**Update to the Application for a Certificate of
Environmental Compatibility and
Public Need Pursuant to Article 10 of the New York
State Public Service Law**

Garnet Energy Center
Town of Conquest, Cayuga County, New York

Case No.: 20-F-0043

January 2022

PROJECT COMPONENT LOCATIONS
GARNET ENERGY CENTER, LLC
TOWN OF CONQUEST, NY

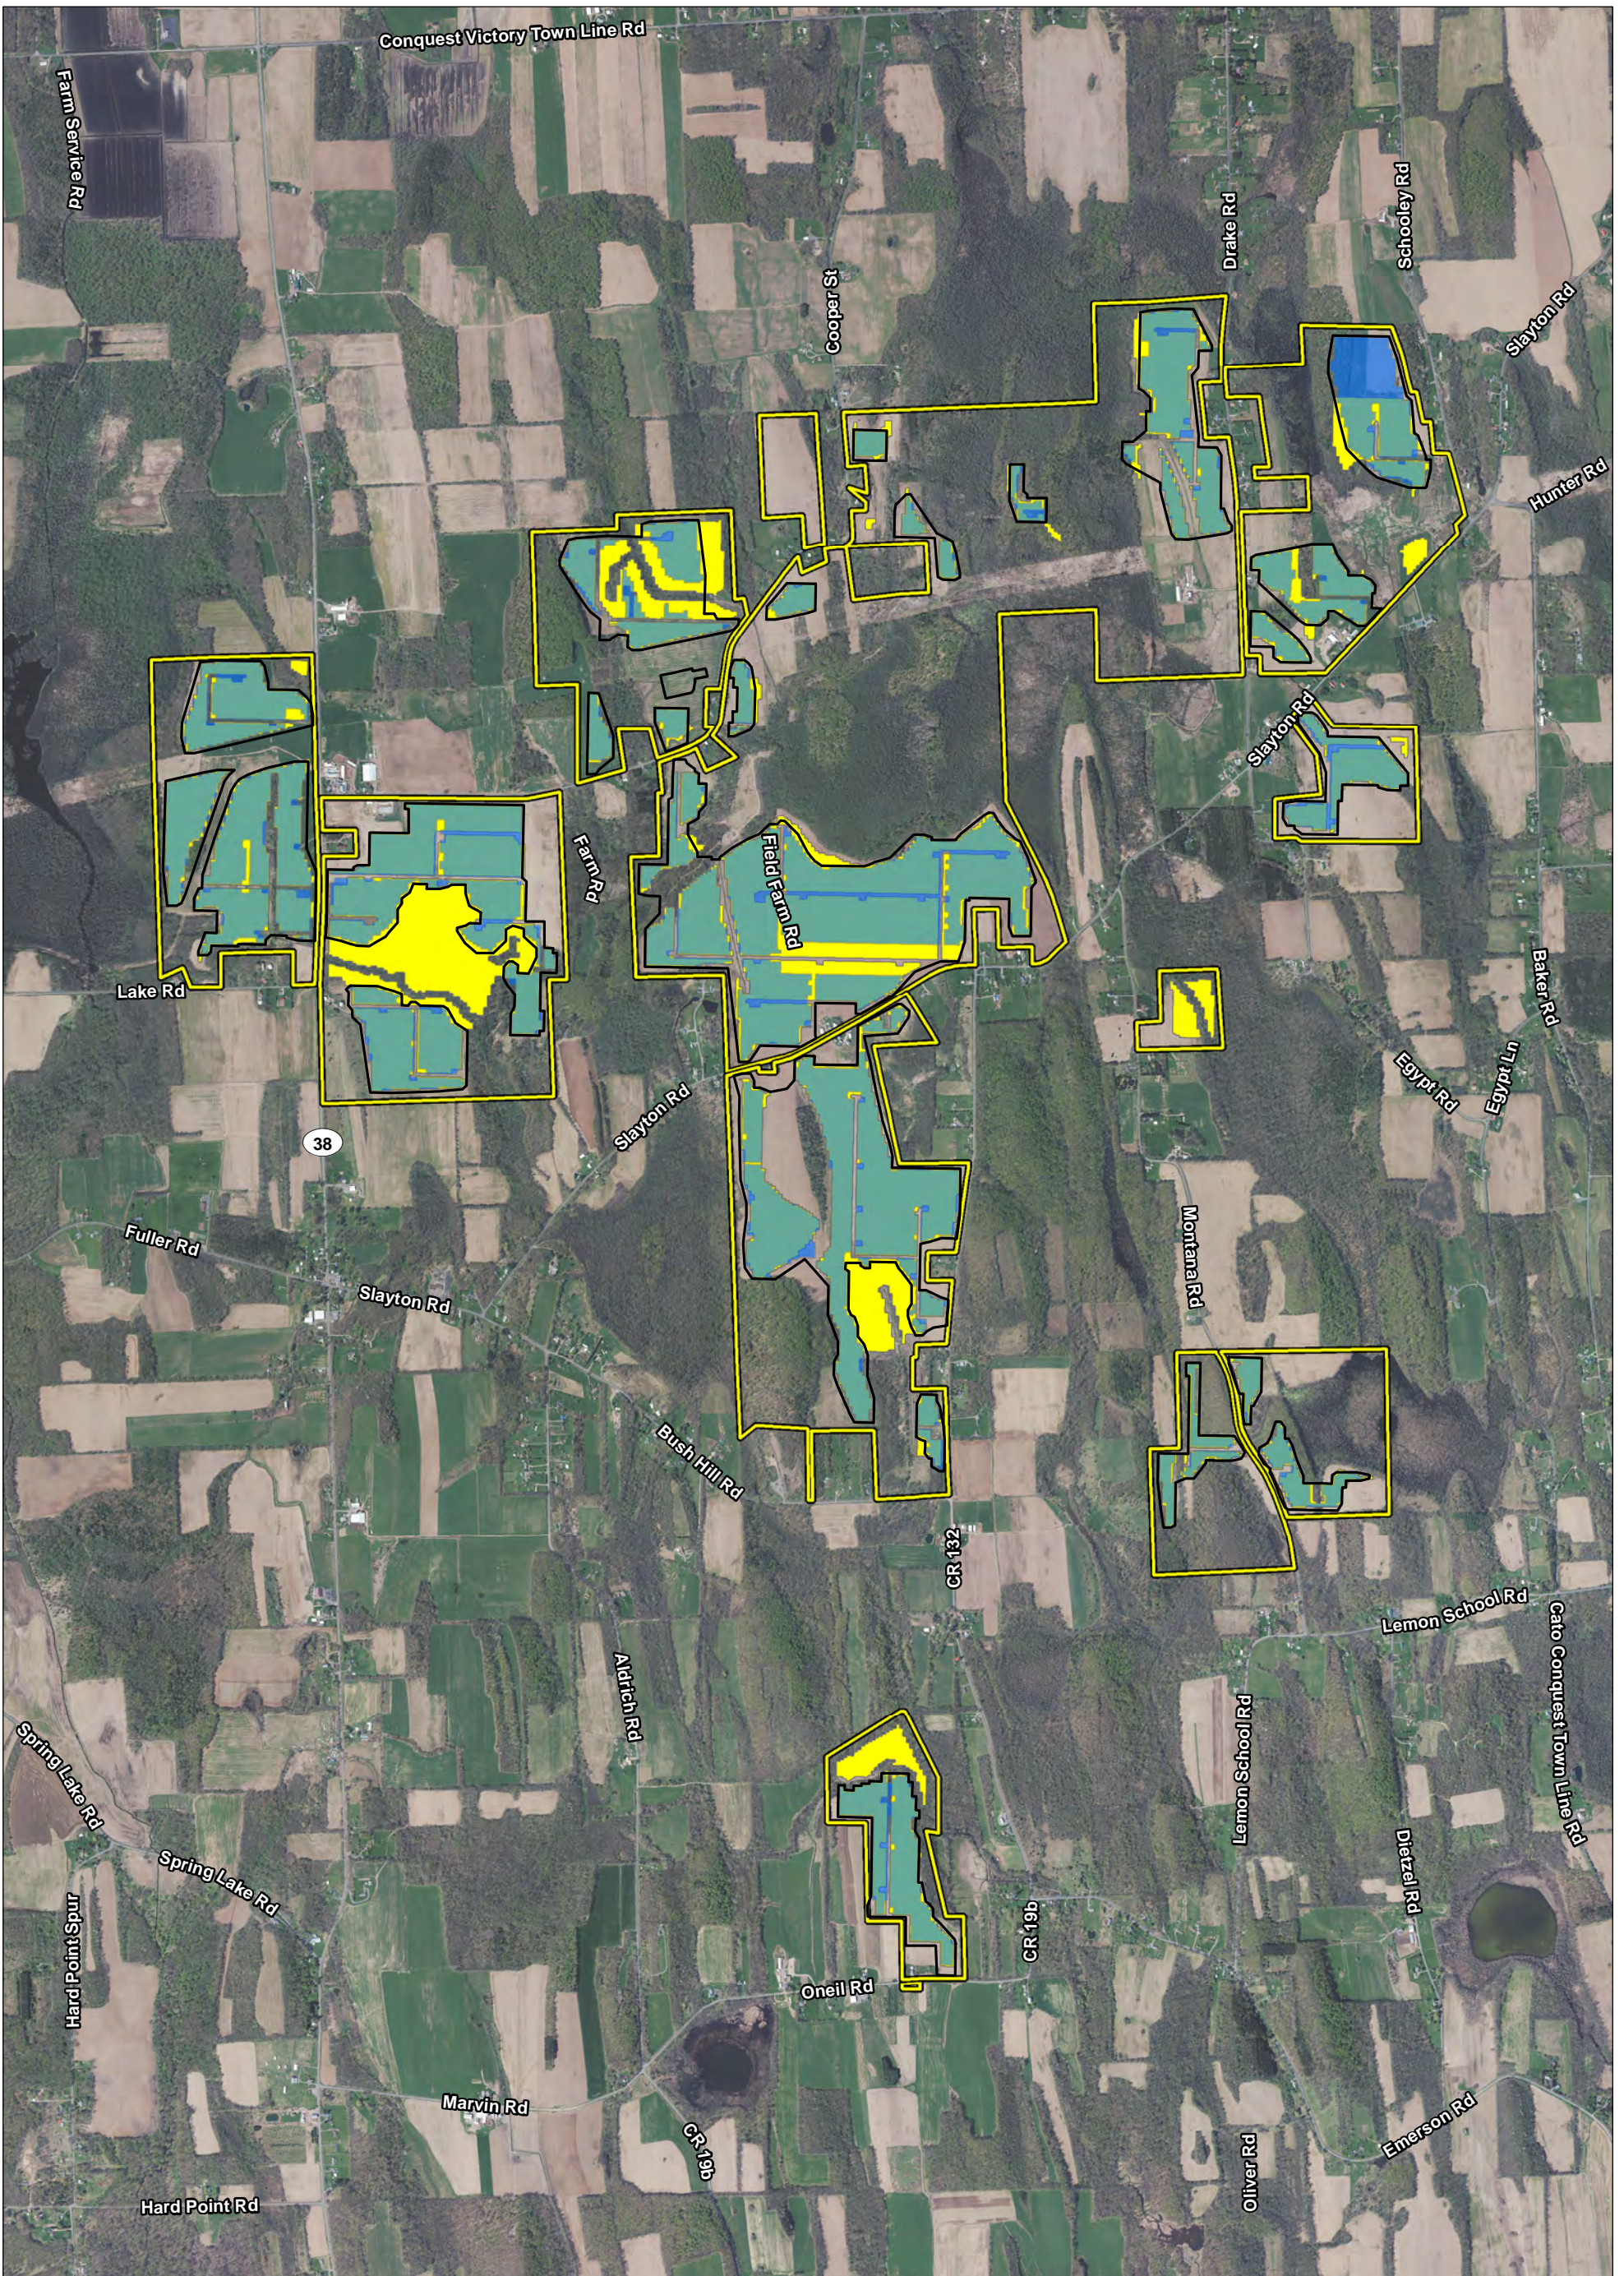
Figure 24-1, presented in Attachment P herein, shows the proposed layout updates. Overall, the total area of panels and racking systems that will cover the Project Area was reduced from approximately 512 acres to 326.76 acres and the fenced-in area that will consist of Project Components was reduced from approximately 1,054 acres to 901 acres as a result of the update. In order to still achieve this significant reduction in proposed solar arrays and still achieve the Project's required generating capacity of 200 MW, a minor addition of arrays is proposed in an area not visible to adjacent landowners. This area is located in the northeastern portion of the Project west of Schooley Road, where approximately 13.8 acres of panels have been added to an area where they were not previously proposed. Refer to Inset 1 in Figure 24-1 for this area of added panels. An updated viewshed analysis was performed with the inclusion of the added panels (and proposed removal of others) but with a focus of understanding any potential new visibility to residences along Schooley Road. Based on the updated viewshed analysis, a new visible area extends into the open field to the north where no members of the public are expected to be, where no existing residences exist, and would likely be visited infrequently by the landowner. As seen in Inset 1 of Figure 24-1, this new area of visibility totaling 5.3 new acres (0.008 square miles) of visibility does not impact residences on Schooley Road nor any aesthetic resources. Project-wide, with both the additional and removed solar arrays, visibility is reduced by 0.26 square miles (7.45 percent). Also, to supplement the visual study for the residences on Schooley Road east of the added panels, a Line of Sight analysis was performed at a representative property. As observed in Inset 1 of Figure 24-1, a forested area exists between the added panels and Schooley Road residences that are to the east. This forested area is also on a hill. Both vegetation and terrain are expected to preclude westerly views to the added array area from nearby eastern residences as demonstrated in Line of Sight Profile Figure 24-2.

- PROJECT AREA
- SECURITY FENCE
- AREAS OF ARRAY REDUCTION
- AREAS OF ADDITIONAL ARRAY
- UNCHANGED AREA OF ARRAY
